Squeaking / Creaking from Seat Back Cover

Vehicles Affected

Models	Model Year	Model Type	VIN Range	Vehicle-Specific Equipment
Cayenne	2019 - Present	9YA/ 9YB	N/A	N/A

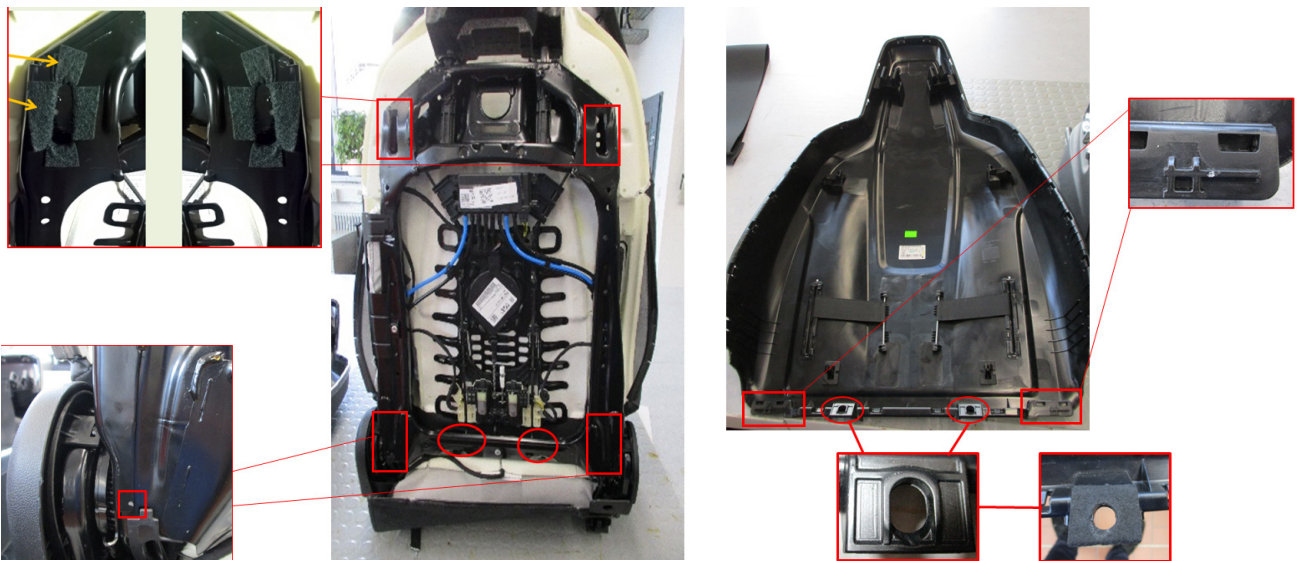
The customer complains of squeaking / creaking from the seat back area.

Contact between the plastic seat back cover and metal frame makes noise as a result of the stick-slip effect. Insulating the contact points with felt will remedy the noise.

Use felt tape to insulate three pairs of contact points

1. The first pair is around the large holes at the top of the seat back frame.
2. The bottom of the seat back cover has two tabs in the center area that attach to metal tabs on the lower bar.
3. There are two contact areas at the bottom outer area of the seat back cover that also need insulating.

The two large holes at the top of the seat frame have been insulated in production, as shown in the photos, since 10-27-2020. The other points have not been insulated in production at this time.
